Project
 19-21 HIGH STREET
 MARKYGATE
 AL3 8PG

Drawing
 PROPOSED
 STREET ELEVATIONS

Drawn By	EG	Date	23.08.2022
Checked By		Date	
Approved By		Scale	1:100 @ A1
Drawing No.	5940 PL06	Rev.	C

No.17
 No.19-21 HIGH STREET
 No.23
 PROPOSED SOUTH-WEST ELEVATION

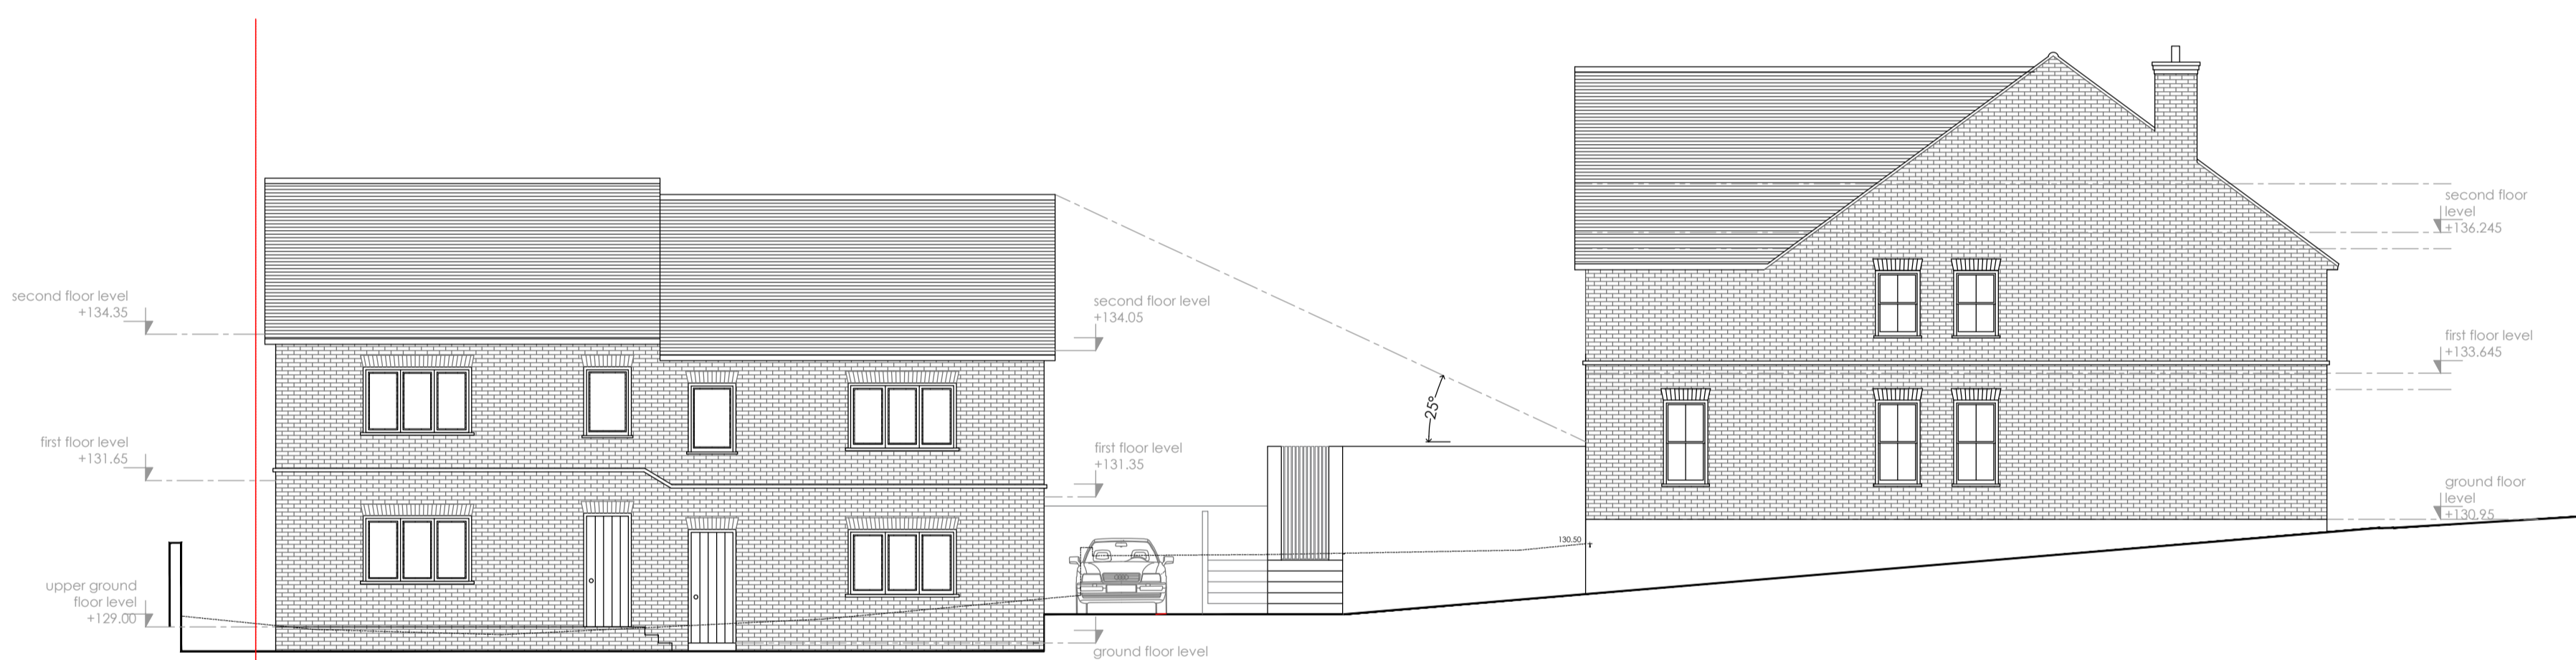
Rev.	Detail	By	Date
A	* 3no. dormer windows omitted and replaced with conservation roof lights. to units 1.2 & 3, reflected in SW elevation.	DM	29.03.23
	* Door omitted in NW elevation to unit 1 and replaced with window.		
	* Redesign of Units 4 & 5, reflected in SE & NW elevations.		
B	Plans and elevations revised and updated	DM	17.04.23
